ADDENDUM #1

HARDIN ST / O'KELLY ST LCI ROADWAY PROJECT GDOT PI 0011640 CITY OF CONYERS, ROCKDALE COUNTY, GEORGIA

July 6, 2017

CITY OF CONYERS
 OFFICE: PROGRAM DELIVERY
MAINLINE PLAN
 HARDIN/O'KELLY ST. LCI STREETSCAPE
 DRAWING No. 13-005

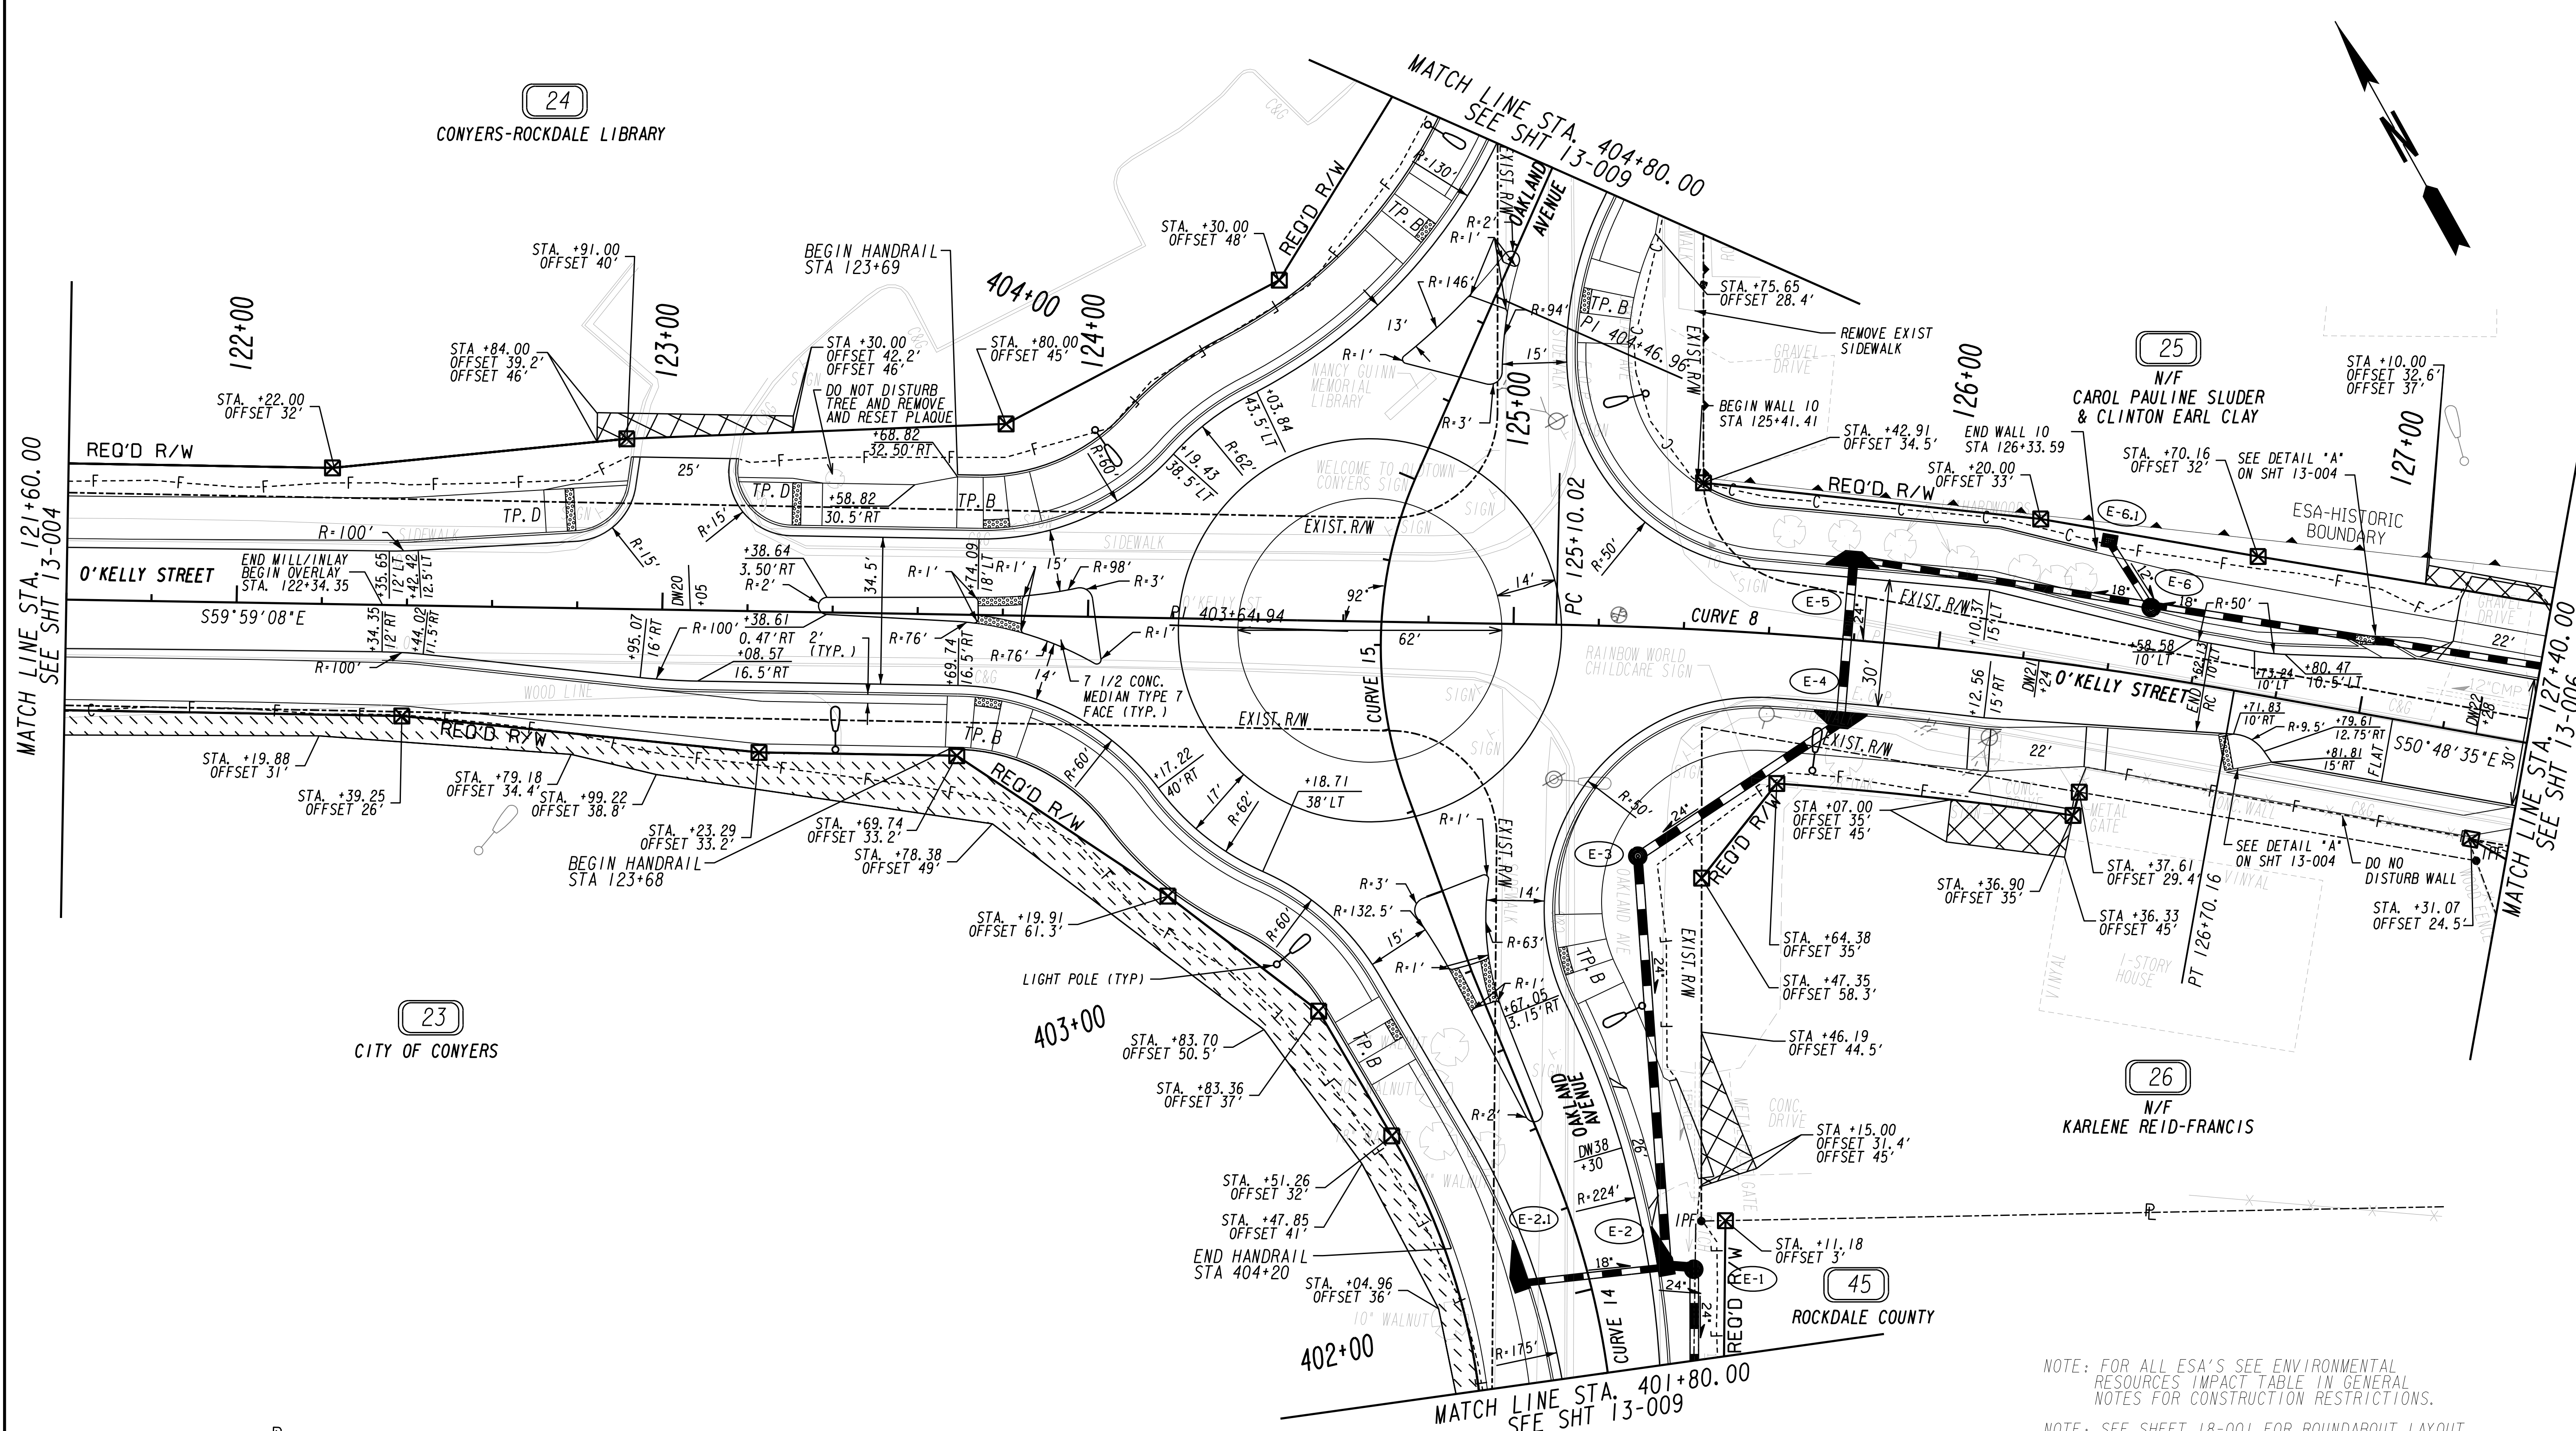
d. Question: Sheet 13-005 has several notes; one which is actually two separate notes on top of each other, seems to address concerns with tree removal and one which appears to address the removal and resetting of a plaque. Can these notes be clarified? The other note which is near the special designed wheelchair ramp, states to "See Detail "A" on Sht. 13-009". Sheet 13-009 does not appear to have this detail, Can the detail in question be provided?

Answer: Sheet 13-005 has been revised to include the correct sheet number for the wheelchair ramp detail and also to correct the overlapping notes.
